Product consolidation RIDERSERIES RCI KITs

Type of notification: PCN PDN Short-term action (<6 months)

Versions without test button:

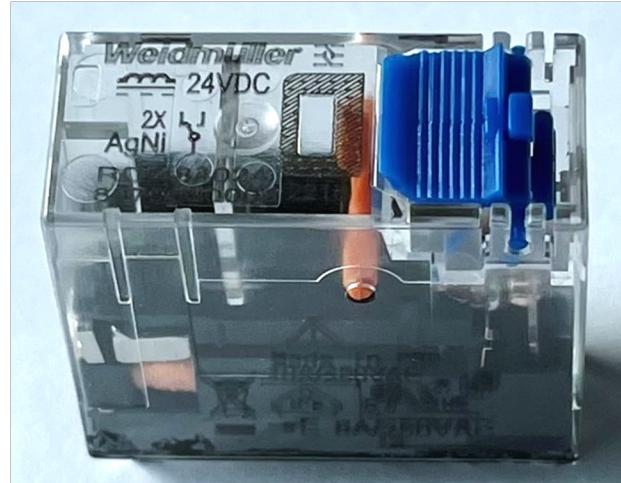
- Changeover of printing of the plugged relay from pad printing to laser printing
- Color coding of the coil voltage of the plugged relay:
 - Is removed for the variants without test button
 - Is done via the color of the test button for the variants with test button (AC: red / DC: blue)

It is a visual adjustment only.
